DRI REGIONAL REVIEW FINDING

Name of Proposal: Poole Mountain DRI 4173

Description: A DRI review of a proposal to construct a detached single-family development with 1,066 units on a 520-acre mostly wooded site traversed by several streams in between Mineral Springs Road and Mt. Moriah Road in Gwinnett County.

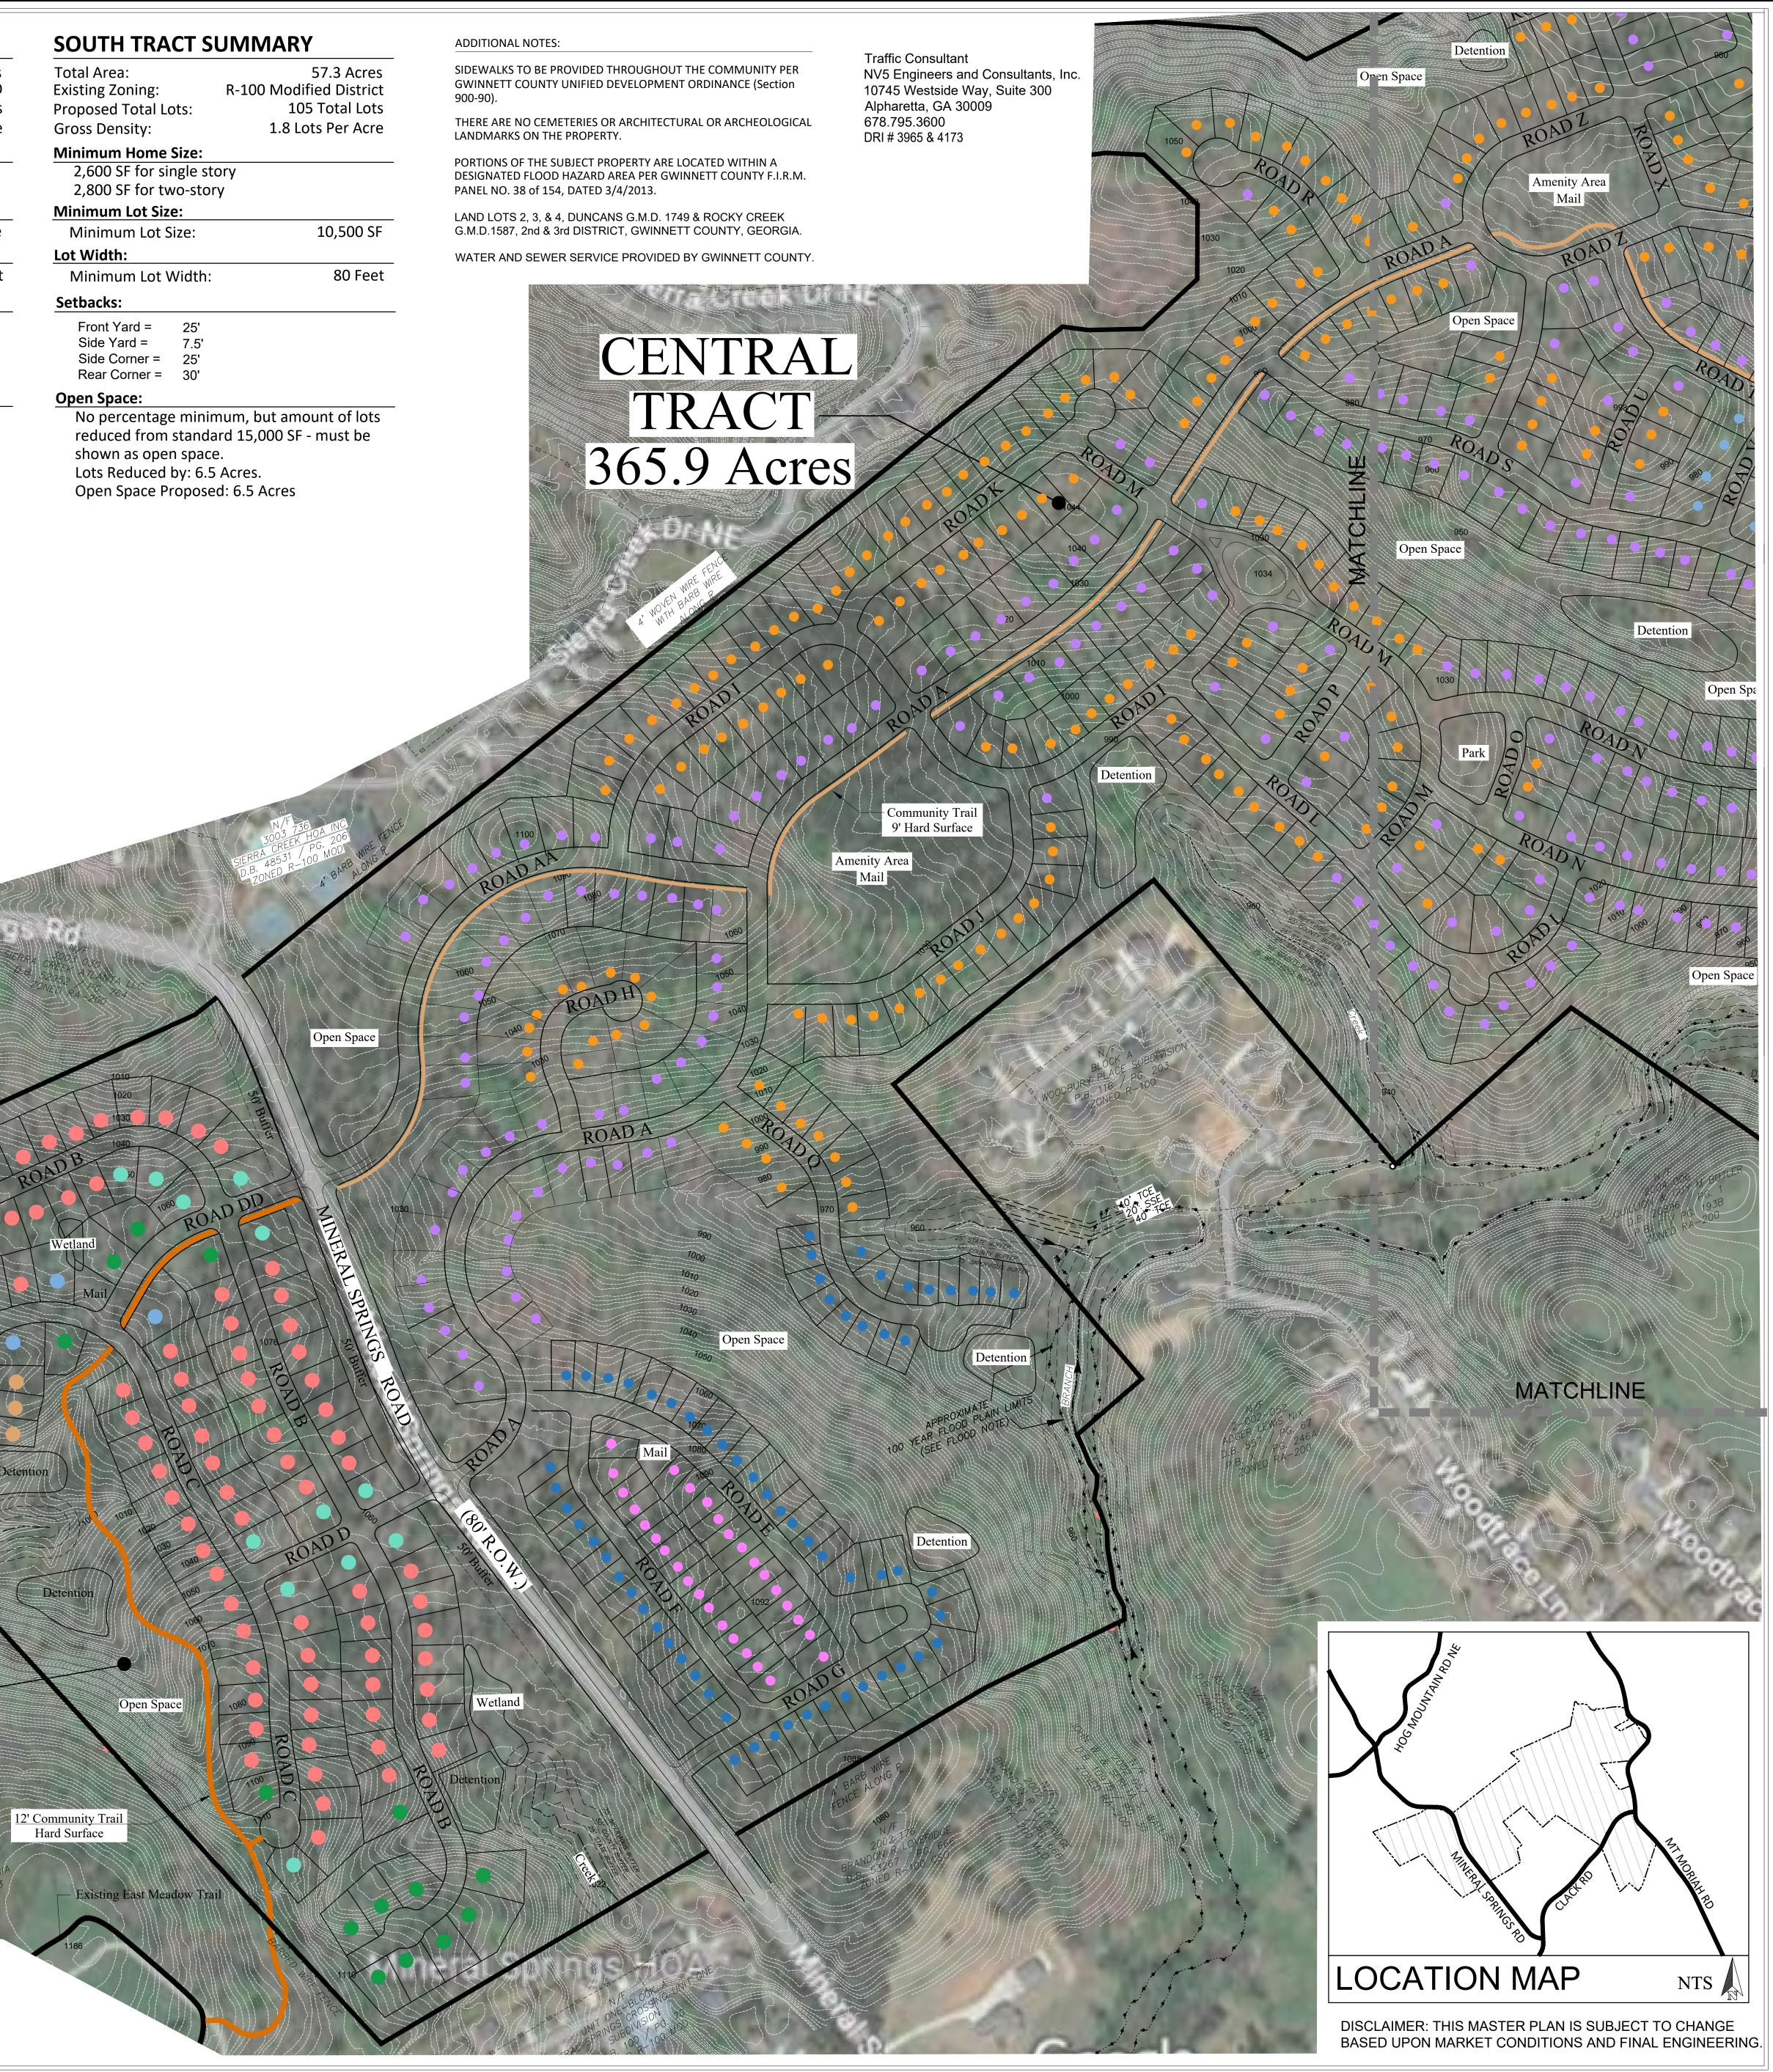
Both the project site plan and the USGS coverage for the project area show a blue-line tributary to Little Mulberry Creek running roughly south to north in the Central Tract of the property to its confluence with Little Mulberry Creek at the northern end of the property near Mt. Moriah Road. A short stretch of Little Mulberry also forms a portion of the northern edge of the property. The USGS coverage and site plan also show a branch of the tributary at the center of the property. The site plan also shows several short branches of f the main tributary, as well as a second stream with two branches in the South Tract portion of the project property. All the indicated streams show the 50-foot undisturbed buffer and additional 25-foot impervious setback that are required under the Gwinnett County Stream Buffer Ordinance, as well as the State 25-foot Sediment and Erosion Control buffer. The only intrusions in the buffers show on the site plans are one transportation crossing and a soft surface community trail. One proposed roadway is close to the 75-foot setback at the headwaters of one branch in the South tract, and several lot boundaries appear to abut the 75-foot buffer. Actual intrusions into the buffers may require variances from Gwinnett County.

The submitted site plan shows the approximate 100-year floodplain limits for the streams on the property. The one transportation crossing across the primary tributary to the Little Mulberry River is the only structure shown within a mapped 100-year floodplain. No other structures, proposed lots or stormwater ponds are shown within the mapped floodplains. The project site should conform to Chapter 700: Floodplain Management of the Gwinnett County Unified Development Ordinance. An application for a development project with any Area of Special Flood Hazard or Area of Future-conditions Flood Hazard located on site shall include a floodplain management/flood damage plan.
